Office Action Summary	Application No. 10/560,800	Applicant(s) LI ET AL.	
	Examiner Vishal Patel	Art Unit 3676

DETAILED ACTION***Continued Examination Under 37 CFR 1.114***

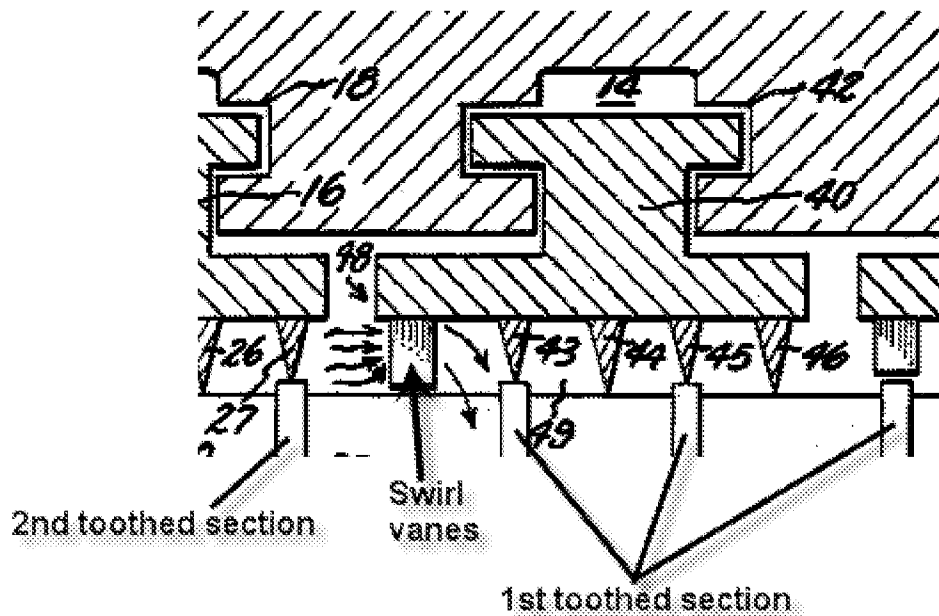
3. Claim 1 is rejected under 35 U.S.C. 103(a) as being unpatentable over Miller (US. 4,420,161) in view of Burnett et al (US. 6,679,681).

Miller discloses an apparatus having a labyrinth seal having a seal section (section having 43-46) on a stator and swirl vanes (e.g. 37 shown below) on the stator, a shaft (e.g. 10) comprising a first toothed section and a second toothed section, a cylindrical surface (surface between 32 and 50, 32 is part of the second toothed section and 50 is part of the first toothed section) of a diameter less than the outer edge of the teeth of the toothed sections and the seal section having teeth (43-46).

Miller discloses the invention as claimed above but fails to disclose that the apparatus having an abradable labyrinth seal having an abradable coating on the stator. Burnett discloses a labyrinth seal (figure 9) having toothed sections (e.g. toothed section having 652 and toothed section having 644) on two members that are relatively rotating (figures 9) and at the same time in another embodiment provides a labyrinth seal (figure 8) having toothed section (section having 548) on a member (e.g. 510) and an abradable seal having an abradable coating (e.g. 550) on another member (e.g. 526). It would have been obvious to one having ordinary skill in the art at the time of the invention to have the seal section of Miller to have an abradable coating instead of teeth as taught by Burnett, to provide seal with reduce solid particle erosion (column 4, lines 52-53 of Burnett) and having toothed section or an abradable is art equivalent.
